Upgrading PowerPC 601™ Evaluation Boards To Support the Intel® SIO 82378ZB

Application Note AN-PPC-002

PowerPC 601 evaluation boards that use the 82378IB SIO chip can be upgraded to use the 82378ZB.

Figure 2. Implementation of PCI Interrupts Using the ZB

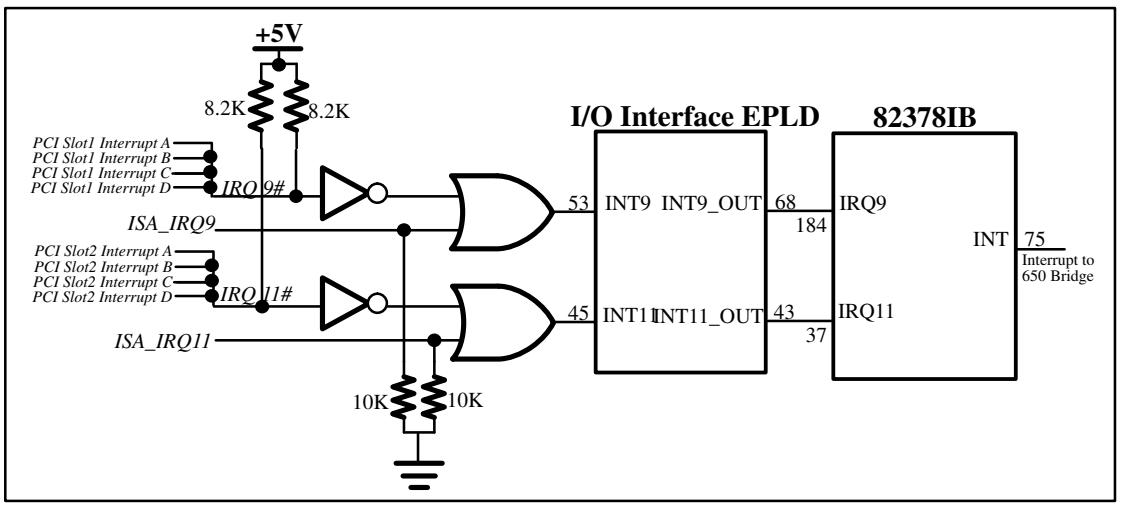
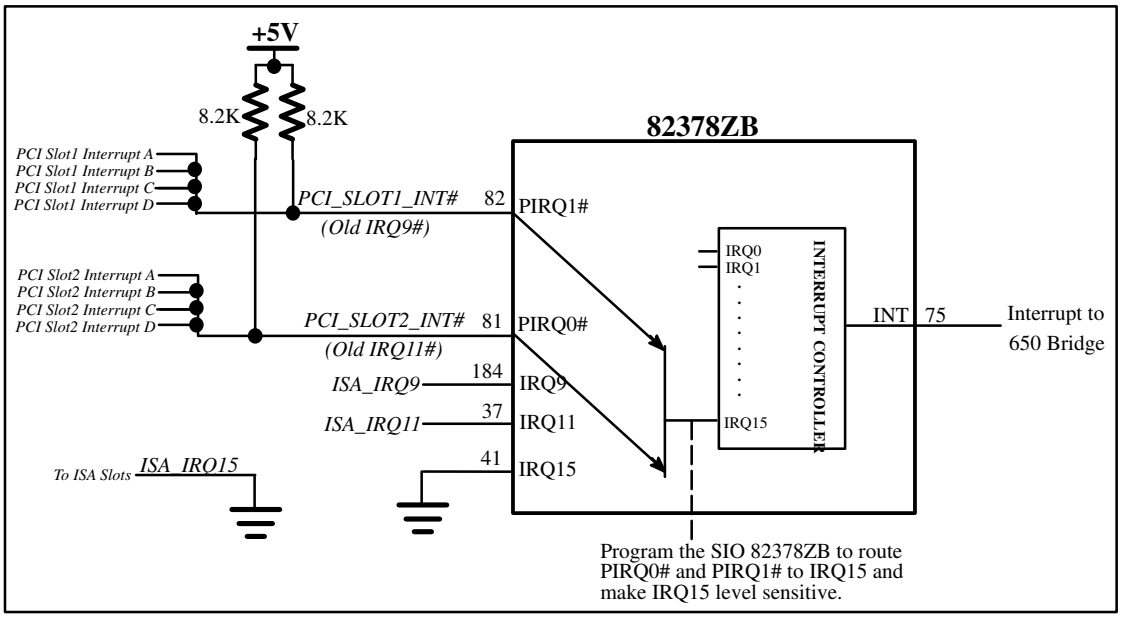
The first releases of the PowerPC 601 evaluation board use the IB chip. As shown in Figure 1, the PCI interrupts from the PCI slots are shared with ISA interrupts and are assigned as follows:

- On the riser card, the four PCI interrupts (A,B,C,D) from each PCI slot are dot-ORed into a single interrupt line. For PCI slot1 this line is called *IRQ9#* and for PCI slot2 it is called *IRQ11#*.
- The interrupt from PCI slot1 *(IRQ9#*) is shared with *ISA_IRQ9* and both are assigned to the IRQ9 level in the interrupt controller.
- The interrupt from PCI slot2 *(IRQ11#*) is shared with *ISA_IRQ11* and both are assigned to the IRQ11 level in the interrupt controller.

The ZB part adds four level-sensitive PCI inputs that can be steered to any unused ISA IRQ level. In addition, the ZB adds level and edge sensitivity that is selectable on an interrupt-by-interrupt basis (versus on a bank-by-bank basis on the IB). With the SIO ZB part, PCI interrupts from the PCI slots can be routed to two of the four PCI interrupt request inputs (PIRQ[3:0]#). The interrupts from PCI slot1 (old *IRQ9#*) should be wired to PIRQ1#, while the interrupts from PCI slot2 (old *IRQ11#*) should be wired to PIRQ0#. The remaining PIRQ2# and PIRQ3# inputs are not used. In addition, the ZB should be programmed such that both PIRQ0# and PIRQ1# are routed (internally to the chip) to the IRQ15 level in the interrupt controller. (PCI interrupts from the PCI slots are no longer shared with ISA interrupts on IRQ9 and IRQ11. All PCI interrupts from the PCI slots are assigned to IRQ15. IRQ15 is not used by the ISA devices.) To route the PIRQ0# and PIRQ1# interrupts to IRQ15, the ZB registers shown in Table 2 must be set. Figure 2 illustrates the PCI interrupt implementation using the ZB.

Pin 41 (IRQ15) of the ZB should not be used for ISA interrupts and should be tied to GND, and the *IRQ15* line on the riser or board riser connector should be tied low in order to prevent any ISA devices from using this interrupt line.

The dot-ORing of the four PCI interrupts (A,B,C,D) of each PCI slot into a single interrupt should remain unchanged from current PowerPC 601 evaluation board implementation.

Pins 68 and 43 on the I/O EPLD become no-connects. Wire IRQ9 (pin 184 in the ZB) and IRQ11 (pin 37) to the ISA slots.

Each PCI slot (ABCD) should be connected to a separate PIRQx input as shown. This allows software flexibility to route the PIRQs to different interrupt levels if required in the future.
